ADDENDUM #02

PROJECT: **RENOVATIONS TO PALMERTON WEIGHT ROOM**
ISSUE DATE: Tuesday, March 5th 2024

RENOVATIONS TO PALMERTON HIGH SCHOOL WEIGHT ROOM

S.1
 SHEET NO. 1 OF 1 SHEETS
 REV. A

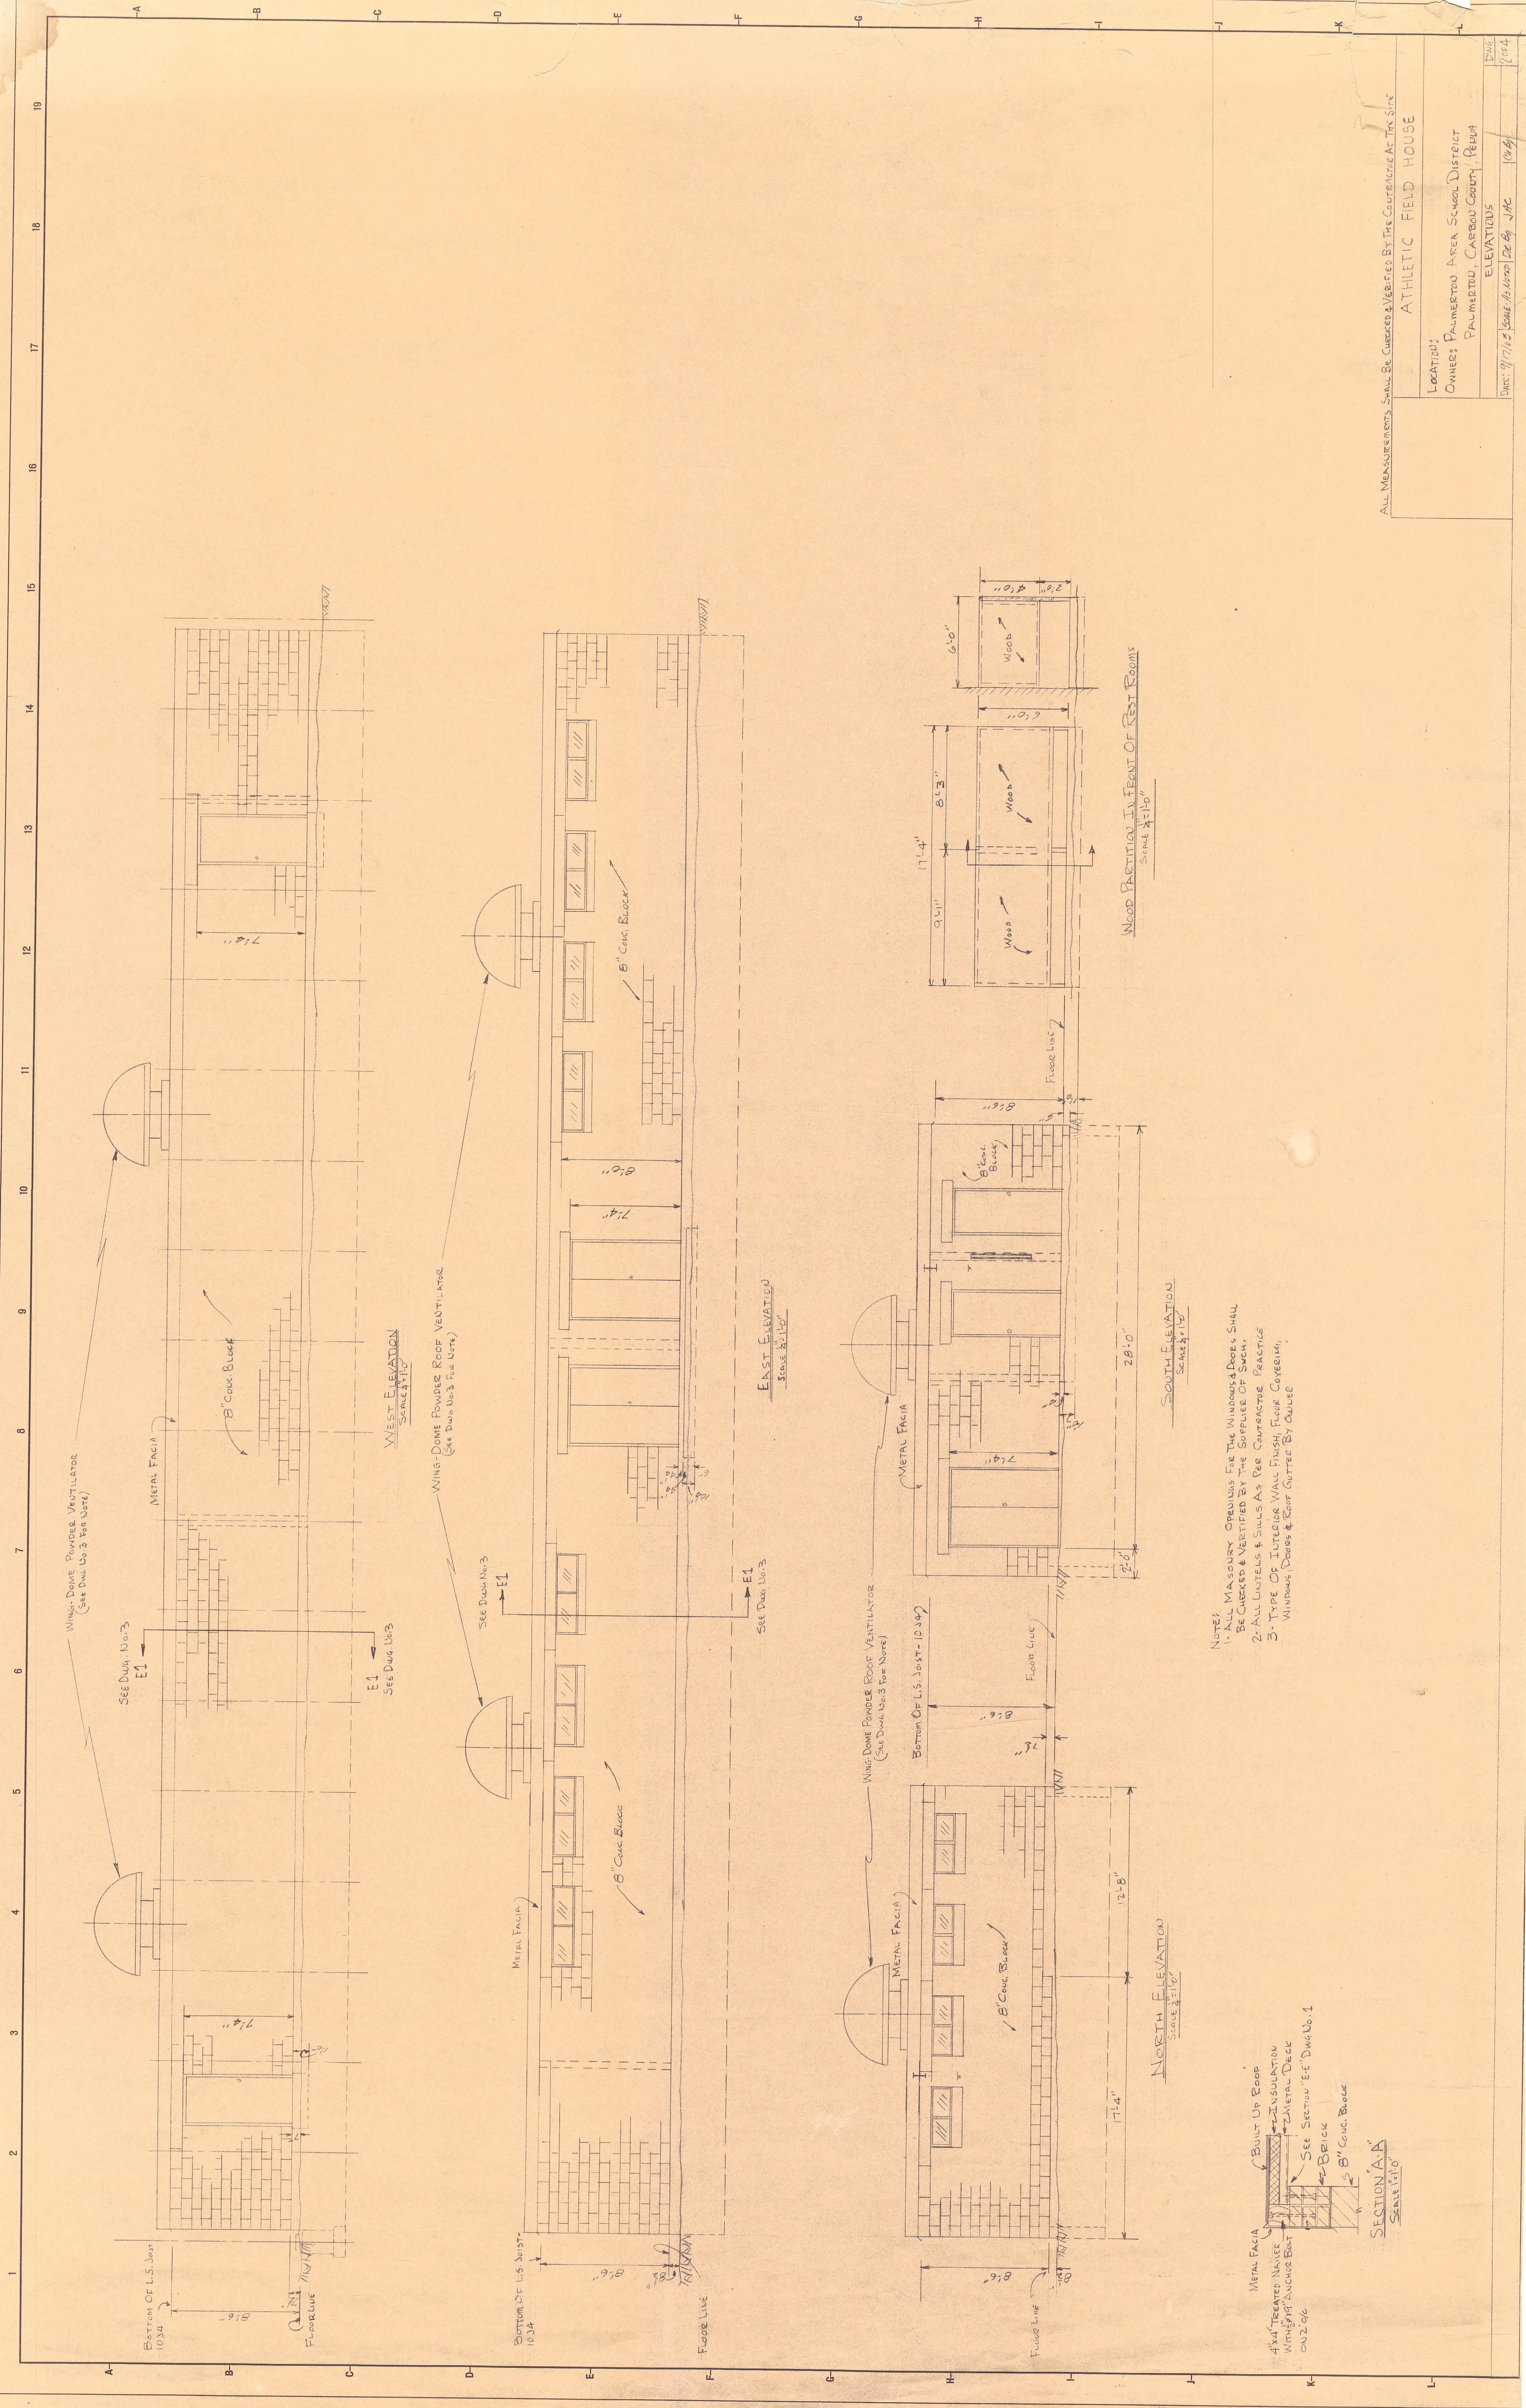
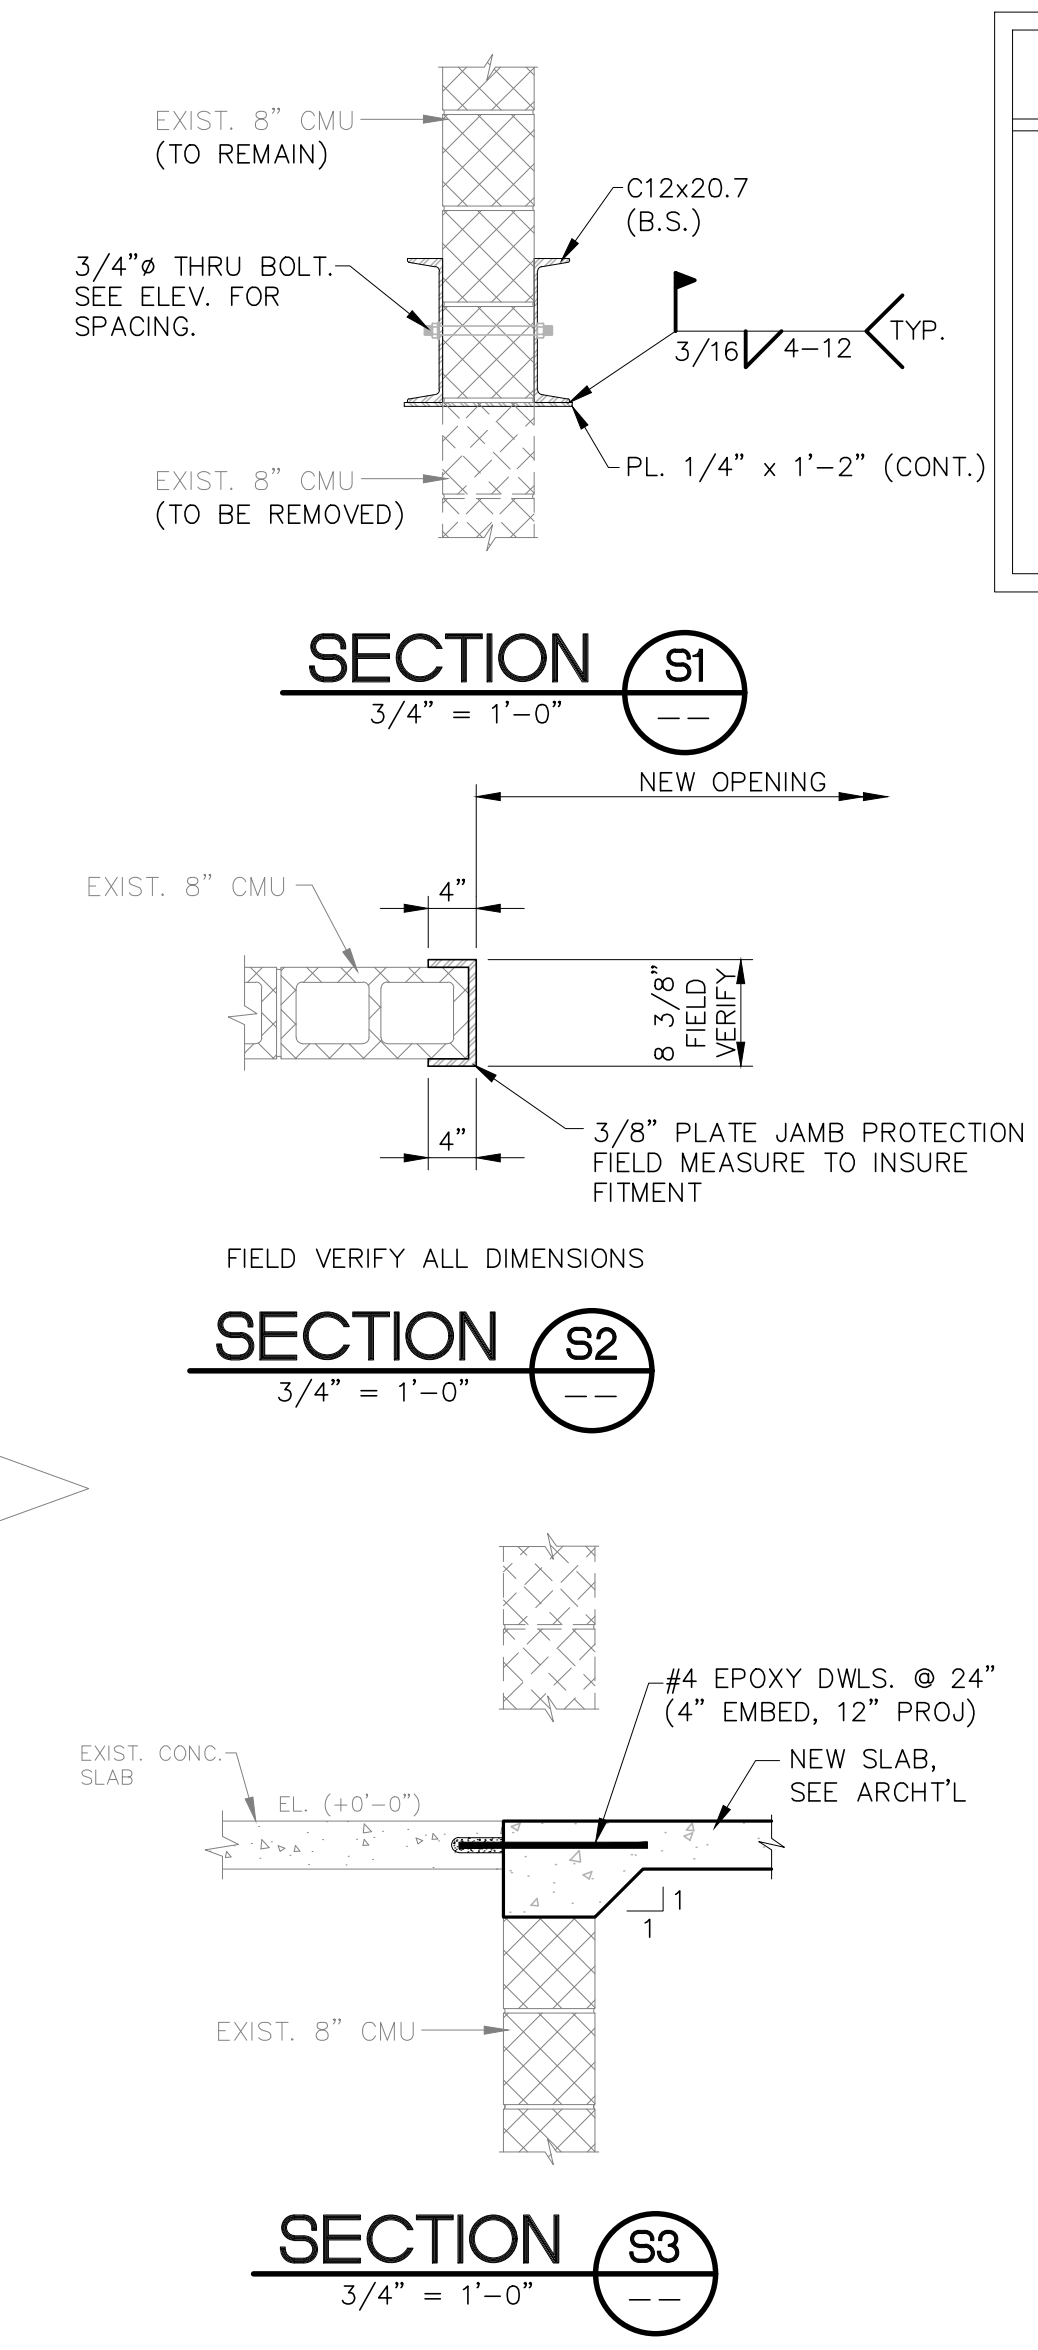
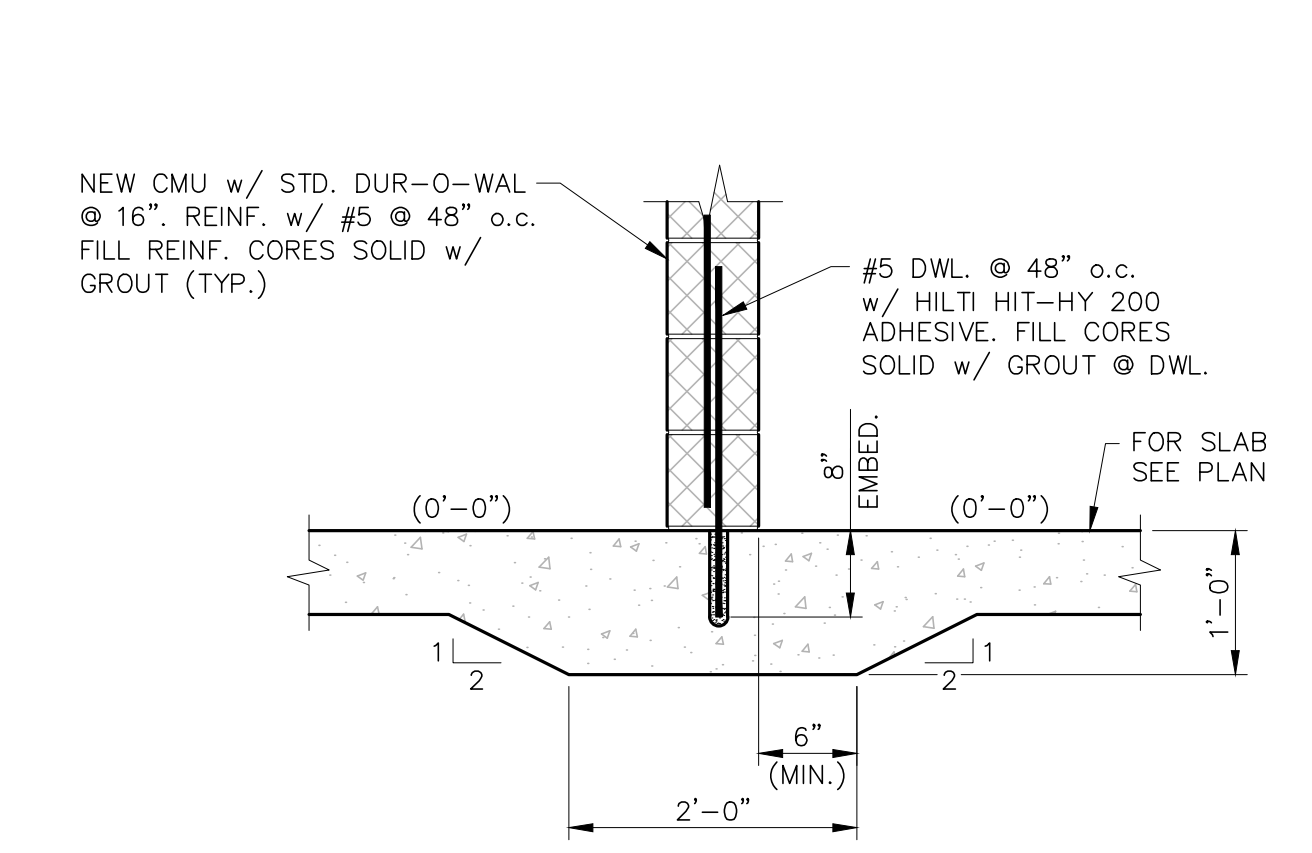
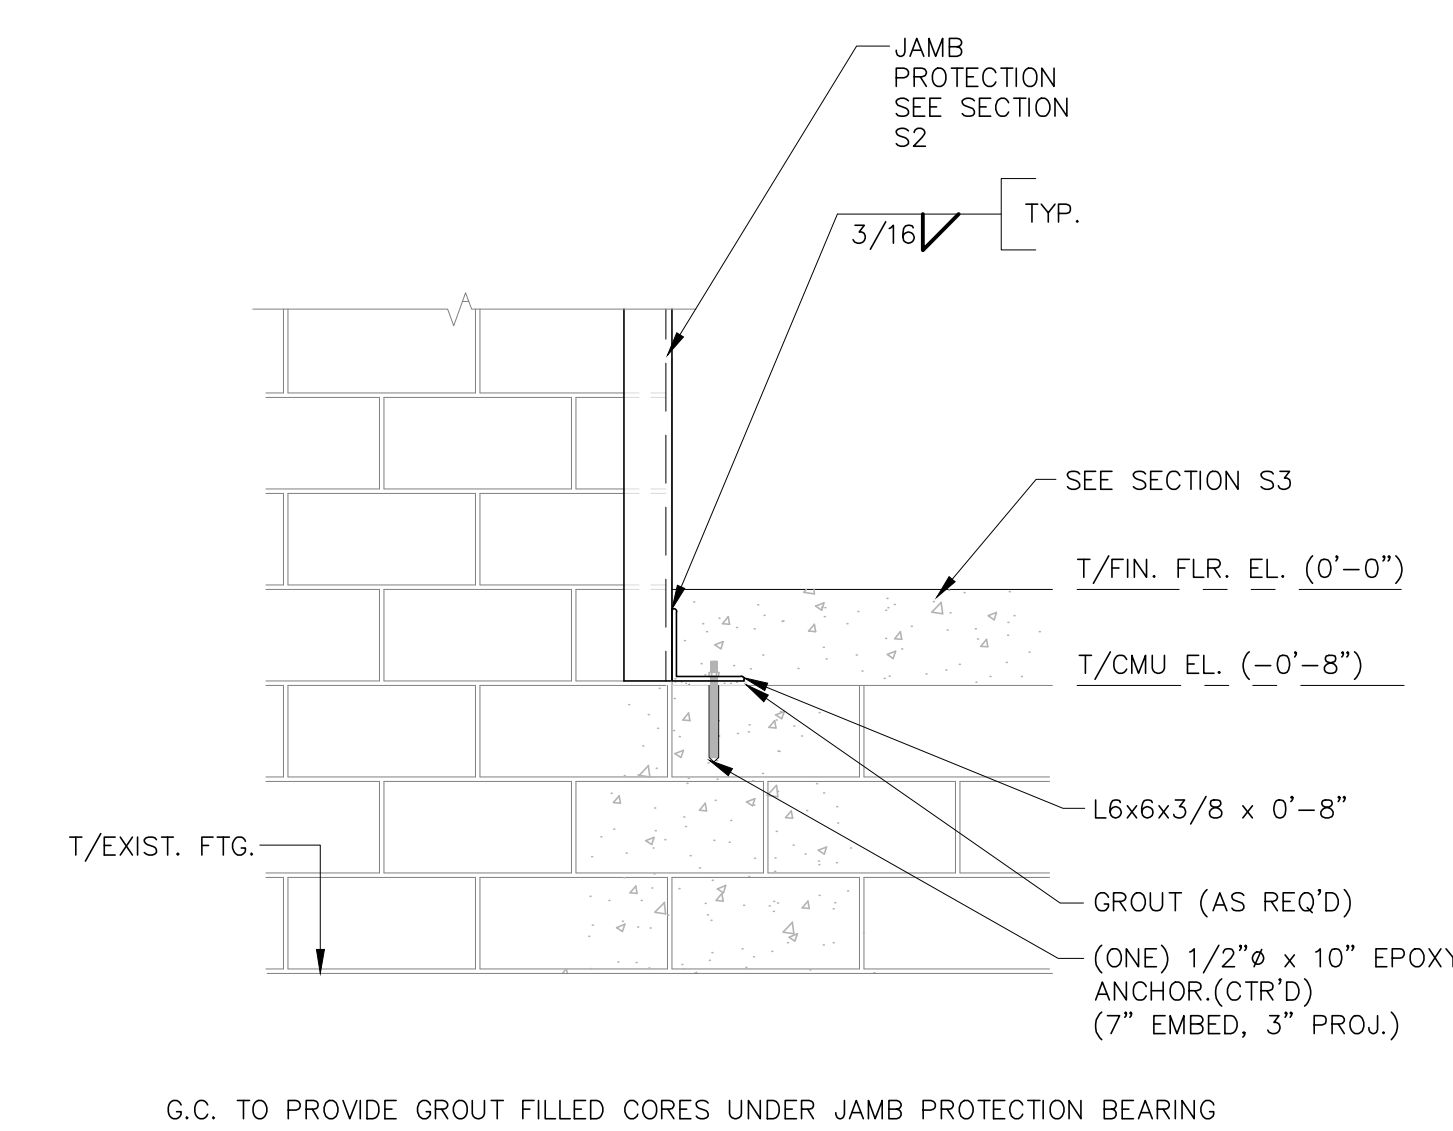
ADDED STRUCTURAL:

S.1 – PALMERTON WEIGHT ROOM TYPICAL STRUCTURAL DRAWING

- RECOMMENDED CONSTRUCTION SEQUENCE**
1. FIELD LOCATE WHERE NEW C12 CHANNELS WILL BE INSTALLED. NOTE ANY INTERFERENCES.
 2. INSTALL NEW C12'S ON EACH SIDE OF WALL TO CREATE NEEDLE BEAM. FULLY TIGHTEN ALL THRU-BOLTS
 3. CUT AND MINIMALLY REMOVE EXIST LINTEL, CMU AS REQUIRED TO INSTALL NEW JAMB PROTECTION.
 4. INSTALL NEW JAMB PROTECTION ON BOTH SIDES OF NEW OPENING
 5. REMOVE DOOR FRAME, EXIST. LINTEL AND CMU IN 6' MAX SECTIONS AND INSTALL NEW BOTTOM PLATES. CONTINUE REMOVING CMU AND INSTALLING PLATES IN 6' MAX SECTIONS THROUGHOUT EXTENTS OF NEW OPENING
 6. REPAIR EXISTING FLOOR AS REQUIRED
 7. PAINT AS REQUIRED
